Report to the Honorable Don Young,
House of Representatives

November 1985

RADIATION ACCIDENT

Incident at Clear Air Force Station, Alaska

Figure 2.3: Key Lock-Out System Design Specifications Versus FSI Procedures

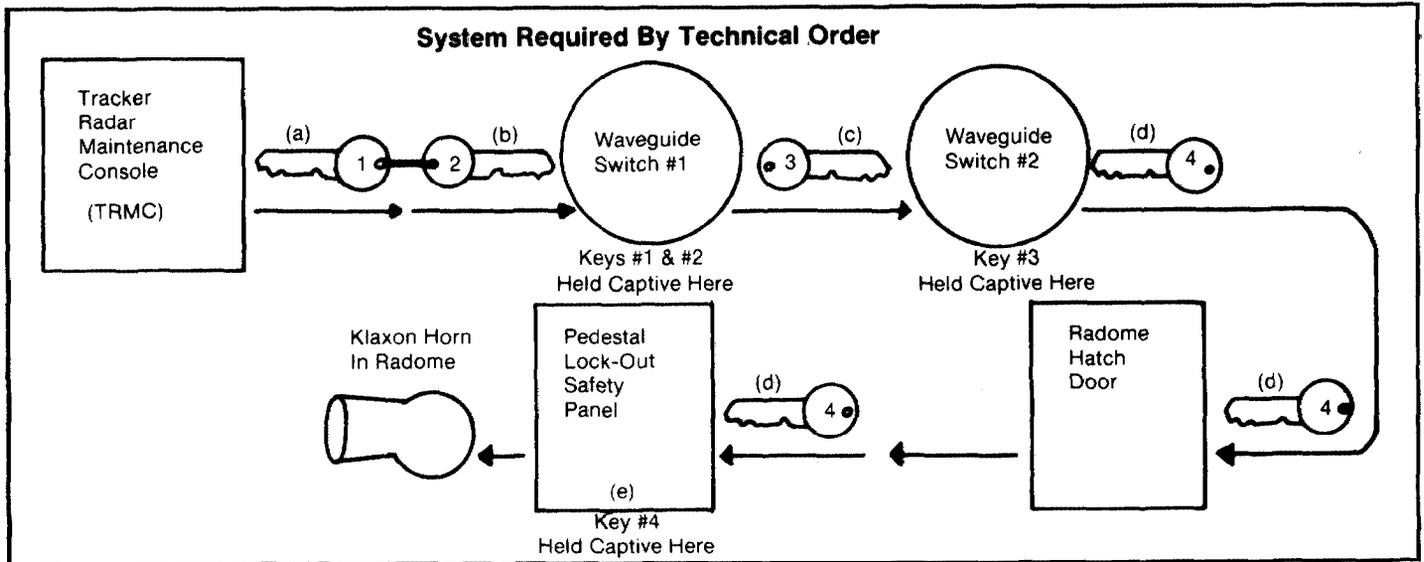
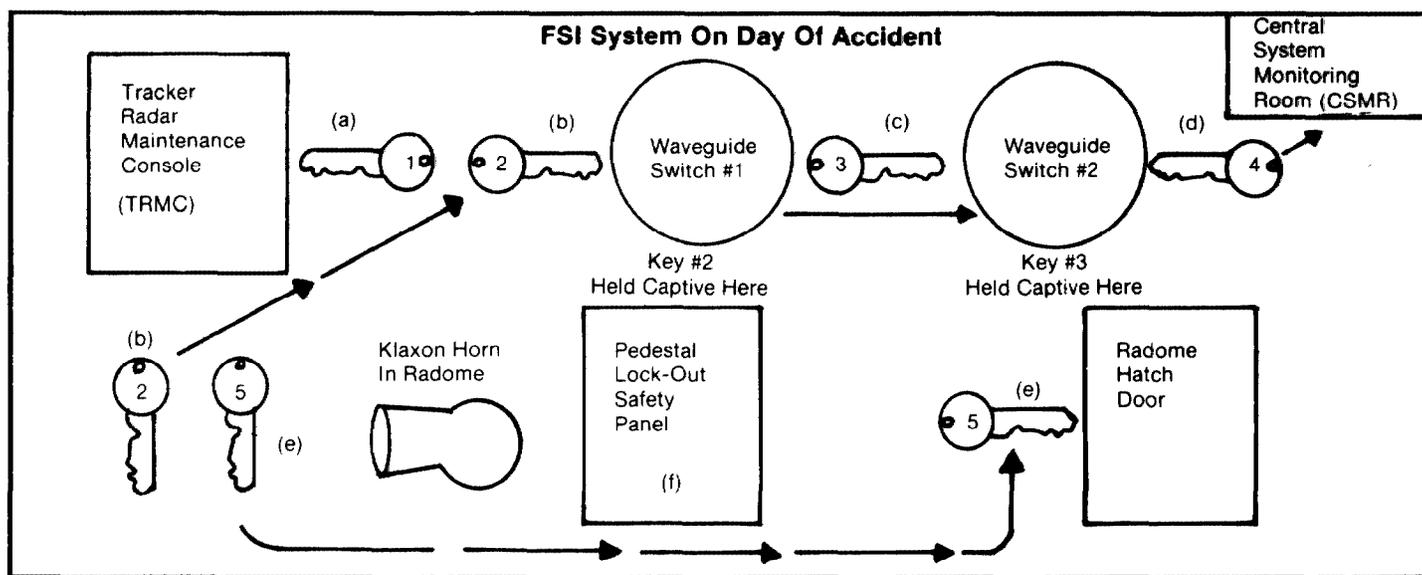
Even though the contract and related technical orders provide clear and extensive guidance on operation and use of the tracking radar safety system interlock, FSI instructions to employees, covering radome access procedures, omit significant elements of the system. FSI site instructions do not treat key #1 as a part of the interlock system. Consequently, on the day of the accident, this key was left in the console while the team leader performed the preventive maintenance routine, leaving the antenna operable and capable of emitting radiation. Key #2, which is the first waveguide switch key, and normally hung by the Tracking Radar Automatic Monitoring (TRAM) room door, along with the radome hatch door key (#5), had been separated from key #1.

- conform the safety system interlocks to specifications and follow all technical order procedures for entering and exiting the radome;
- change the waveguide layout, wiring and automatic switching functions to properly align prime transmitters with corresponding radars;
- require the contractor to comply with minimum manning requirements in monitoring and control rooms, in accordance with the Statement of Work;
- review the contractor's technician assignment practices to ensure that technicians are fully trained and qualified in the monitoring and control rooms they are assigned to; and
- assure that only trained Quality Assurance Evaluators, fully qualified in evaluating contractor compliance with technical specifications are assigned, especially in highly technical areas such as the operation and maintenance of communication and electronic equipment.
